NAVIGATION - GDL 69 SXM DATA LINK INSTALLATION

525 (Citation M2)

SB525-34-106
Page 1 of 5

Figure 1. (Sheet 1)

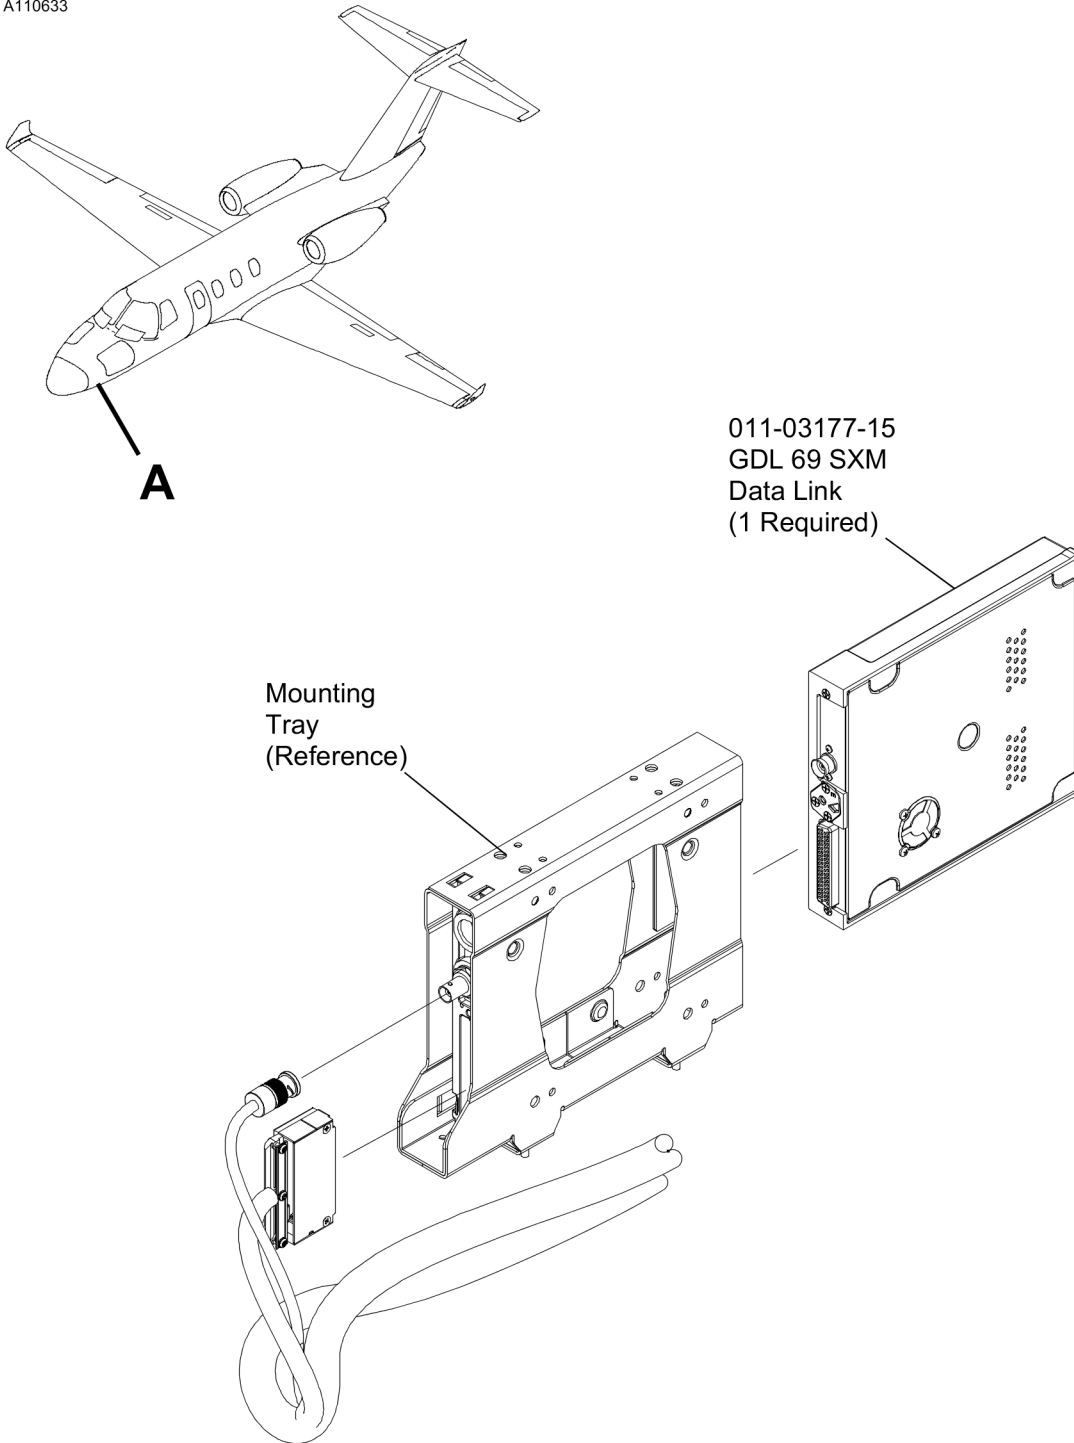
2. Remove the current 011-00987-00 GDL 69 HW SXM Data Link and return to Textron Aviation for exchange. (Refer to the Model 525 (0685 and 0800 and On) Maintenance Manual), Chapter 34, Garmin GDL 69A/69A SXM Data Link System - Maintenance Practices.)

3. Install the new 011-03177-15 GDL 69 HW SXM Data Link. (Refer to the Model 525 (0685 and 0800 and On) Maintenance Manual), Chapter 34, Garmin GDL 69A/69A SXM Data Link System - Maintenance Practices.)

011-03177-15
GDL 69 SXM
Data Link
(1 Required)
